NUCLEAR POWER
SYSTEMS DIVISION

SUBJECT: IN THE MATTER OF 238 NUCLEAR ISLAND
GENERAL ELECTRIC STANDARD SAFETY ANALYSIS REPORT
(GESSAR II) DOCKET NO. STN 50-447

Attached please find the remaining final draft responses to the Instrumentation and Control Systems Branch (ICSB) questions in the Commission's October 5, 1982 request for additional information. These responses reflect the NRC/GE information exchange meetings held in Bethesda October 14 & 15, 1982; San Jose December 7-9, 1982; and again in Bethesda January 11-13, 1983.

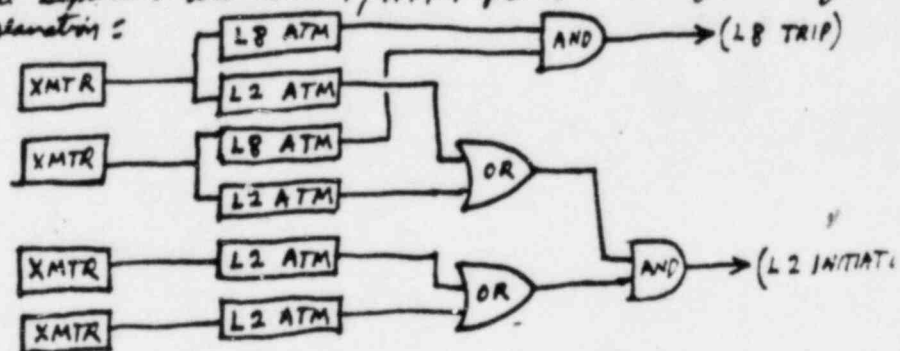
Based on our review, it appears the the proposed logic for manual initiation for several ESF systems is interlocked with permissive logic from various sensors. In some cases, it appears that the permissive logic is dependent on the same sensors as those used for automatic initiation of the system. Our position on this matter is that the capability to manually initiate each safety system should be independent of the permissive logic, the sensors and the circuitry used for automatic initiation of that system. (Refer to Section 4.17 of IEEE Std. 279). Identify each safety system which is interlocked in a manner similar to that described above. Provide proposed modifications or justification for the present design.

In this regard, manual control of actuated devices at the motor control center (MCC) has been typically provided in previous designs. Our review of drawings I-960 A through M indicates that this feature has not been provided for your proposed design. Provide your rationale for not providing local control at the MCC's.

The HPCS subsystem is initiated automatically by a LOCA signal (low reactor water level in a 1 out of 2 twice logic arrangement or high drywell pressure in 1 out of 2 twice logic) or manually by a system level armed pushbutton. In addition, the subsystem can be placed in operation by use of an individual remote manual switch for each valve and the pump. In all three initiation modes, the injection valve is interlocked closed by high water level (level 8) in a 2 out of 2 logic arrangement. If the valve is open, high water level (level 8) will cause it to close.

The level 8 signal is provided by two analog trip modules (ATM's) which are paired with two separate transmitters. These two transmitters in combination with two different ATM's also provide two of the four inputs used in the 1-out-of-2-twice, low-water-level system initiation circuit. The other two inputs come from two additional and separate transmitter/ATM pairs. The following sketch illustrates the above explanation:

The two level 8 ATM's provide the common interlock for injection valve opening in the automatic initiation mode and the two manual initiation modes.
